Subject ▶ Changes on housing and switch

For Models ▶ BO4553, BO4554, BO4561

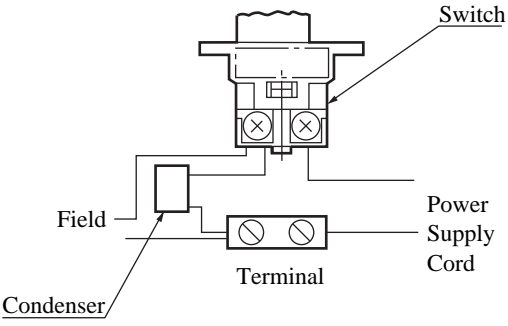
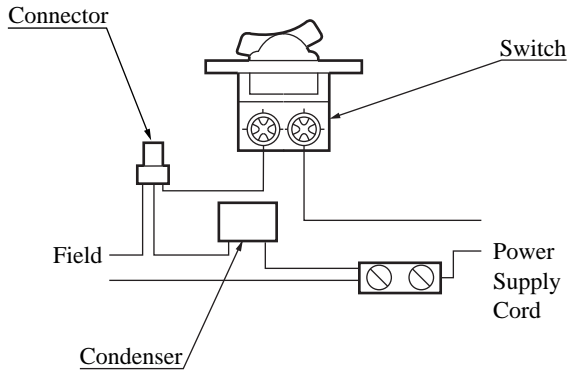
Description ▶ For secure and comfortable one-handed operation, the current housing shape and switch type have been changed.

▶ Current	▶ New
Housing	<p>rather flat top</p> 	<p>rather round top</p>  <p>Part-number for housing-set remains the same.</p>
Switch	<p>Slide-Type ON/OFF Switch</p> 	<p>Rocker Type ON/OFF Switch</p>  <p>Rocker Type ON/OFF Switch Wiring-Diagrams for current and new switches are shown below.</p>
Wiring Diagram	With Condenser

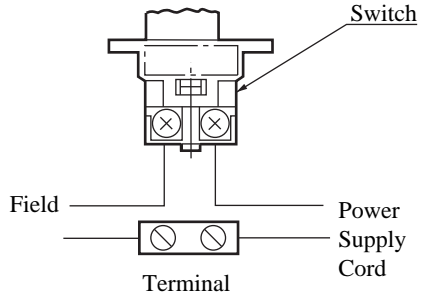
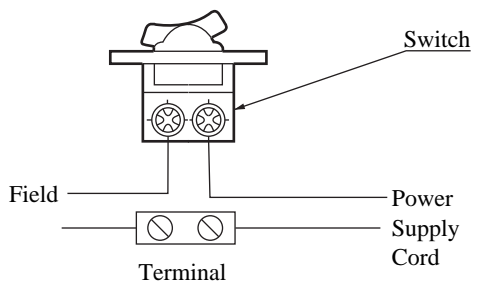
Without Condenser
